STAFF ANALYSIS

CASE NO.:	SLUP-26-1248016	File ID #: 2026-0447
Address:	4733, 4773 & 4775 Memorial Drive, Decatur, GA 30032	Commission District: 4 Super District: 6
Parcel ID(s):	18 012 13 033, 18 012 13 015, 18 012 13 001	
Request:	Application of QuikTrip Corporation for a Special Land Use Permit (SLUP) to allow a drive-through facility (car wash) in the Town Center character area in the C-1 (Local Commercial) zoning district.	
Property Owner(s):	QuickTrip Corporation C/O Eric Bikas	
Applicant/Agent:	QuickTrip Corporation C/O Eric Bikas	
Acreage:	5.23	
Existing Land Use:	Town Center	
Surrounding Properties:	North: C-1 (Local Commercial) South: C-1, R-100 (Residential Medium Lot-100) East: C-1, R-100 West: C-1	
Comprehensive Plan:	Consistent	Inconsistent X

STAFF RECOMMENDATION: DENIAL. (Staff conditions proposed, if approved).

SHEET NUMBER:
 02

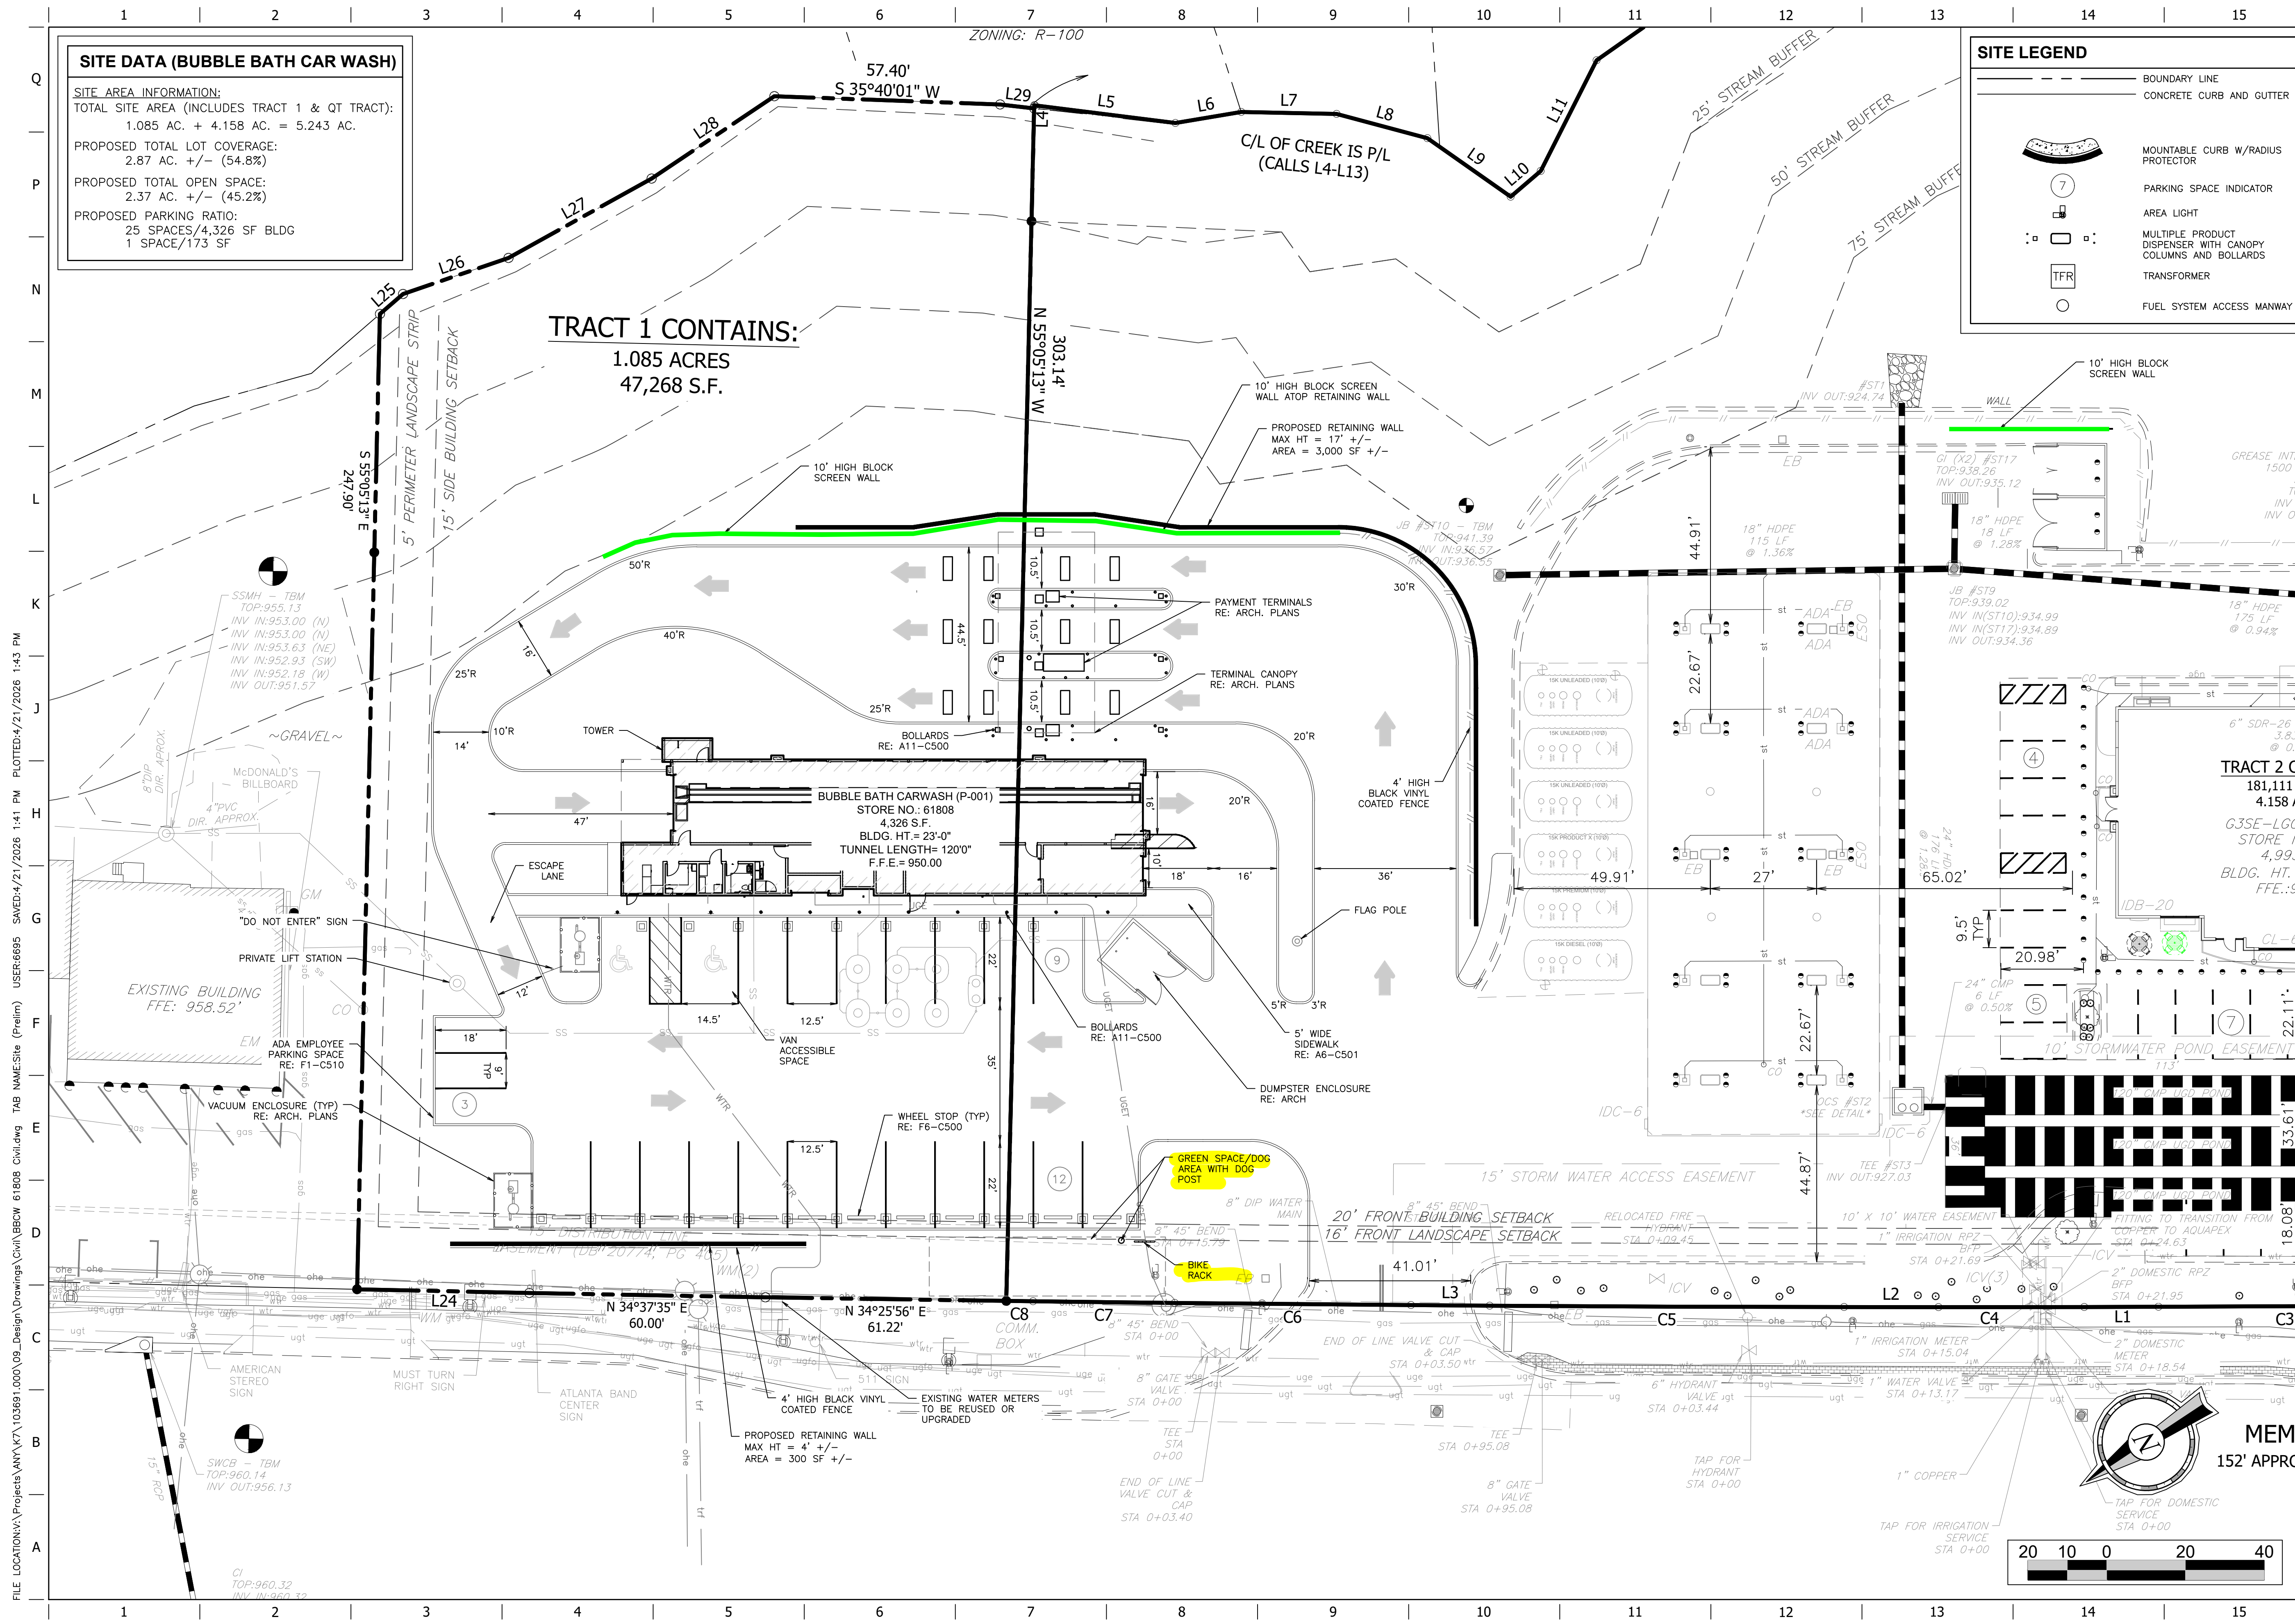
The proposed expansion and assemblage of parcels provide sufficient area to accommodate the use. Based on the submitted site plan “*QuikTrip Bubble bath No.61808 Sheet 02*” (revised and submitted on 4/22)

requirements of Section 2.24.1 (*C-1-Dimensional requirements*) are mostly met, including: open space (45.2%), 50-foot undisturbed buffer adjacent to the single-family residential neighborhood to the southeast, and Section 6.1.5 (*Off-street parking*). The Applicant has stated two (2) variances will be sought (1) Front building setback variance (20ft-60ft is allowed, proposed 103ft +/-) and (2) Wall height variance (12ft is allowed, proposed 16ft - 17' once the final wall plans are produced). The applicant did not display compliance with Supplemental Regulations in Section 4.2.13 (A) *required queuing capacity*, it appears to be adequate. Additionally, Section 5.4.3 (*Streetscape elements and dimensions*) sidewalk dedication and landscape strip (Table 5.1 specifies 20ft is required) are not displayed per submitted landscaping plan "*QuikTrip Bubble bath No.61808 Sheet 04*". The site fronts Memorial Drive, a Major Arterial and Georgia State Route (Transportation Division comments enclosed). Proposed hours of operation are 8:00 AM to 7:00 PM in winter and 8:00 AM to 9:00 PM otherwise, with no overnight operations. The enclosed tunnel design is expected to minimize external impacts.

1. As shown on the site plan "*QuikTrip Bubble bath No.61808 Sheet 02*" (revised and submitted on 4/22) the subject site will be developed to minimize impacts to adjacent properties, including:

- Orientation of vacuum and service areas will be located between the proposed building and Memorial Drive;
 - Maintenance and/or enhancement of existing tree buffers adjacent to residential properties to the southeast of the subject site;

- Placement of refuse and service areas will be located between the proposed building and Memorial Drive and screened in accordance with County standards.

3. The site plan shall be revised to clearly demonstrate compliance with minimum vehicle queuing requirements for car wash facilities in accordance with Section 4.2.13(A). Queuing shall be internal to the site and shall not impede drive aisles, parking, or access points.

4. Prior to issuance of land disturbance permits, the applicant shall revise the site plan "*QuikTrip Bubble bath No.61808 Sheet 02*" (revised and submitted on 4/22) to demonstrate full compliance with Section 5.4.3 (*Streetscape elements and dimensions*), including required sidewalks, landscape strips, streetlights, and street trees along Memorial Drive.

5. The site plan "*QuikTrip Bubble bath No.61808 Sheet 02*" (revised and submitted on 4/22) shall enhance pedestrian connectivity between the public sidewalk along Memorial Drive and building entrances, including clearly defined walkways and connections to the outdoor seating and greenspace areas.

7. The site plan shall include an expanded, covered outdoor seating area integrated with the convenience store entrance. Final design, location, and materials shall be subject to written approval by the Planning Deputy Director prior to any Land Disturbance Permit (LDP).
8. A publicly visible greenspace shall be incorporated into the site design on either the carwash or convenience store subject site.
